# UNITED STATES PATENT AND TRADEMARK OFFICE

APPLICATION NO.	FILING DATE	FIRST NAMED INVENTOR	ATTORNEY DOCKET NO.	CONFIRMATION NO.
10/811,037	03/26/2004	Thomas E. Falgout SR.	530	9542

## Office Action Summary

ANNOTATED SHEET

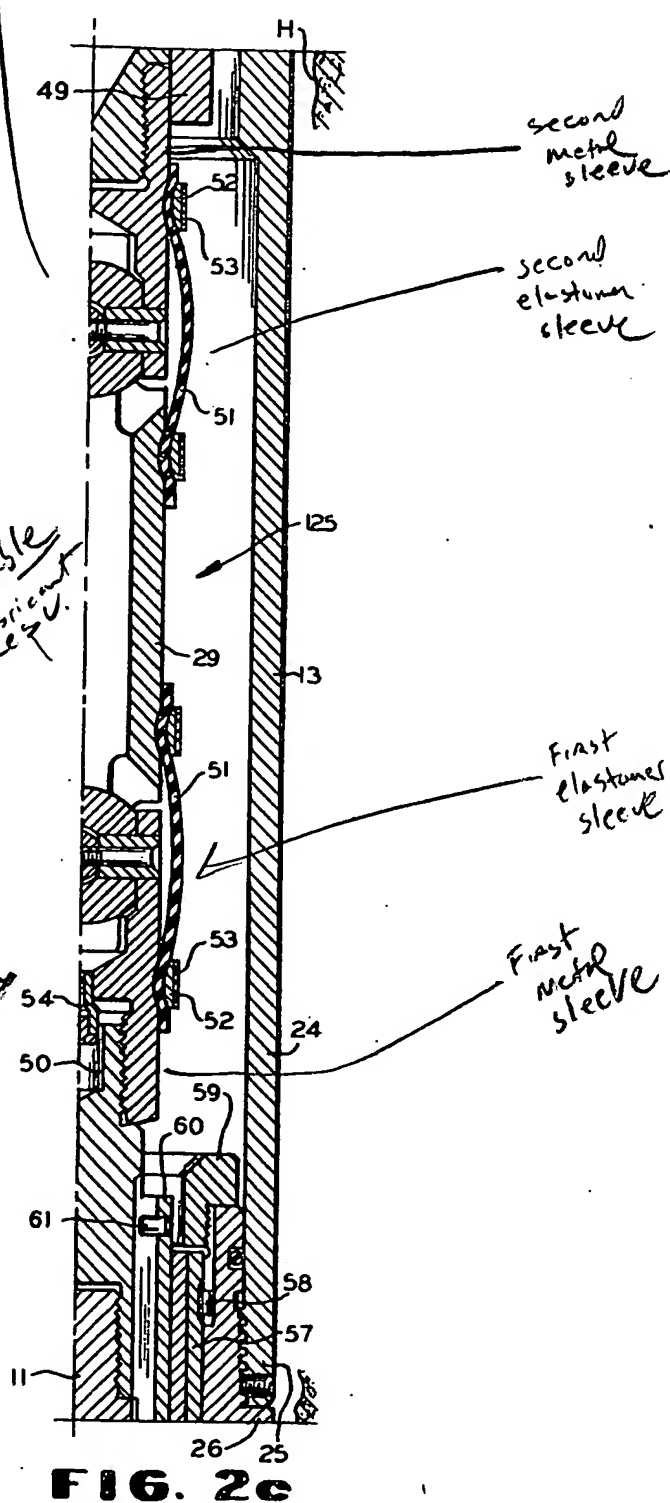
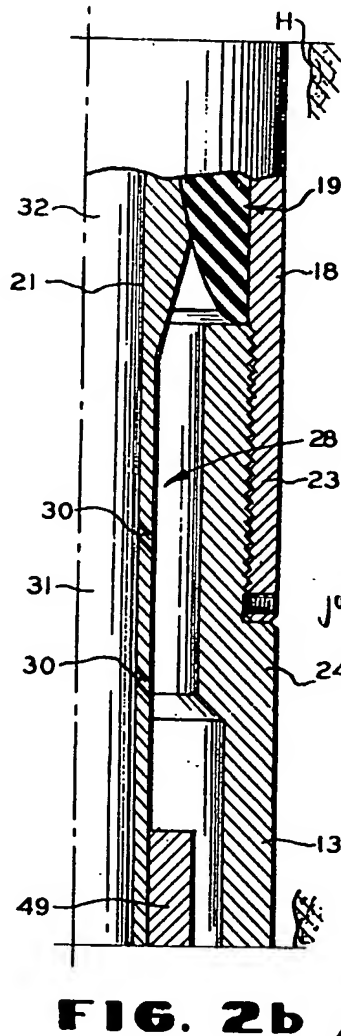
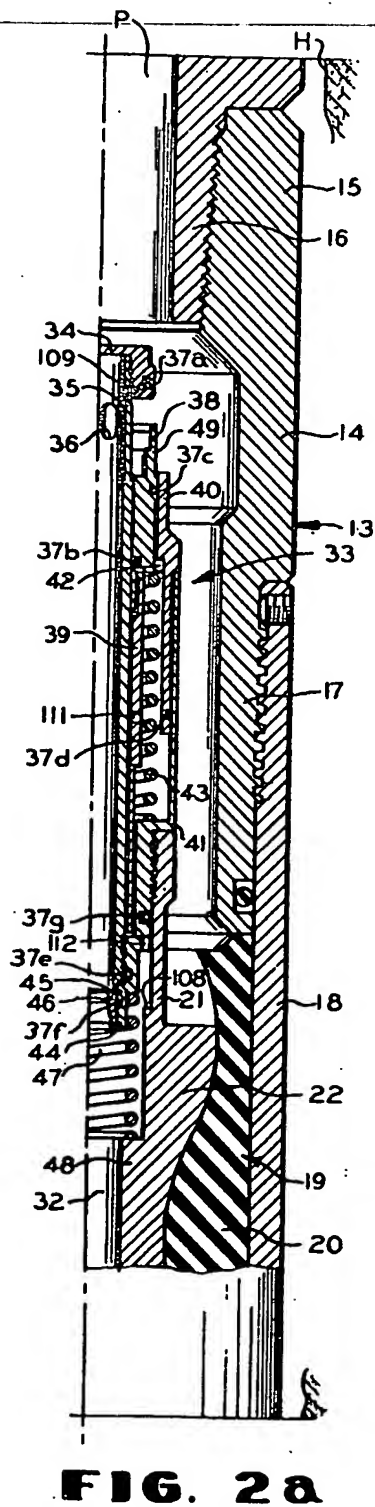
10. Claims 1-4, 6 & 7 rejected under 35 U.S.C. 102(b) as being anticipated by Beimgraben, US 4,263,788. Figs. 1 shows a coupling assembly 29 for connecting, as an axially serially continuation, a down hole motor rotor 21 to the down hole motor output shaft 11. Fig. 2c shows the coupling assembly 29 comprising (see the annotated copy attached): a first flexible coupling, having a lubricant space therein, arranged for connection, at a first end, to the output shaft 11; a second flexible coupling, having lubricant space therein, arranged for connection at a third end to the first coupling and arranged, at a fourth end arranged for connection to the motor rotor 21; a first flexible seal situated in the first flexible coupling, arranged to function as a closure for the lubricant space between the first and second ends, the seal comprising a first metal sleeve sealingly and peripherally attached at one end of the first coupling, a first elastomer sleeve sealingly and peripherally attached at one end to the distal end of the first metal sleeve sealingly and peripherally attached at the other end to the other end of the first flexible coupling; a second

flexible seal situated in the second flexible coupling, arranged to function as a closure for space between the third and fourth ends, the seal comprising a second metal sleeve sealingly and peripherally attached to one end of the second coupling, a second elastomer sleeve peripherally attached at one end to the distal end of the second metal sleeve and “sealingly peripherally” attached at the other end to the other end of the second flexible coupling; and two variable lubricant reservoirs with fluid channels to provide lubricant to the couplings.

Second flexible coupling

second metal sleeve

second elastomer sleeve

variable lubricant region

first elastomer sleeve

first metal sleeve

first flexible coupling
